| DISPOSITION                                                                                                                                                                                                                                                                                                                    |                  |          |      | PROJECT : 4th METHANOL PROJECT                                                                |          |          |                   |
| SIGNATURE                                                                                                                                                                                                                                                                                                                      |                  |          |      | TMA REMOVAL FOR METHANOL                                                                      |          |          |                   |
| DATE

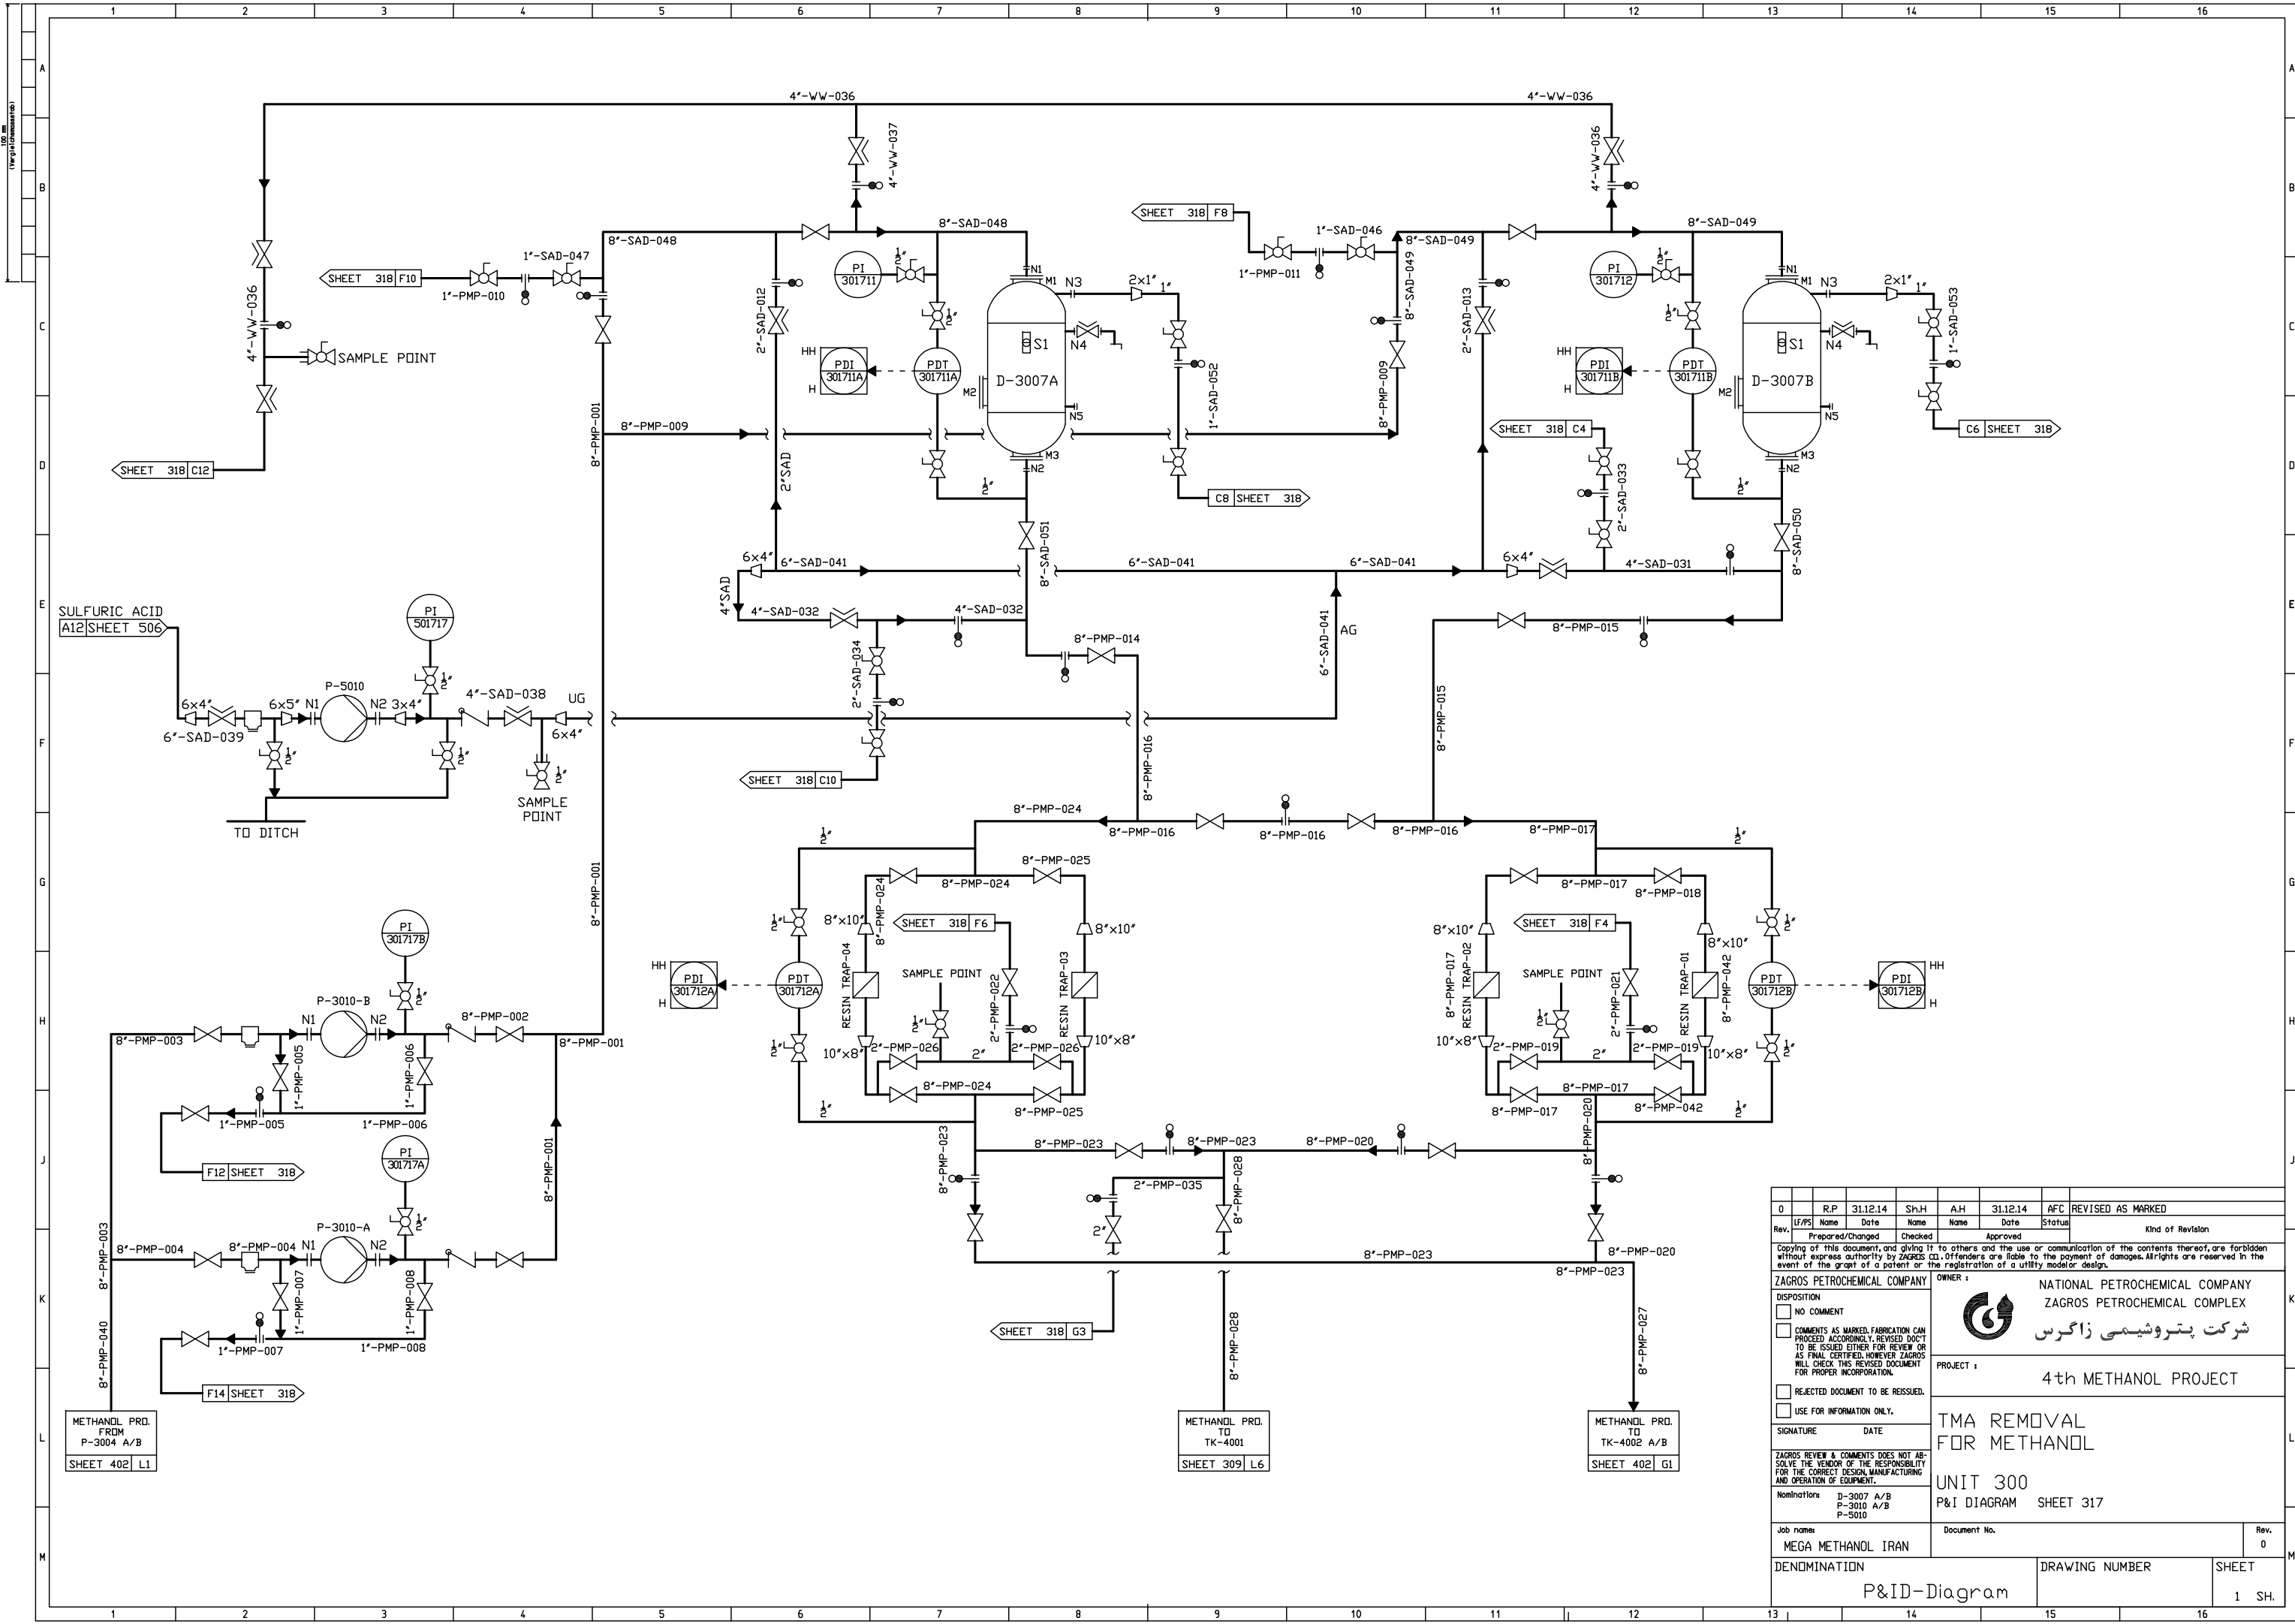
| 0                                                                                                                                                                                                                                                                                                                              | R/P              | 31.12.14 | Sh.H | A.H                                                                                           | 31.12.14 | AFC      | REVISED AS MARKED |
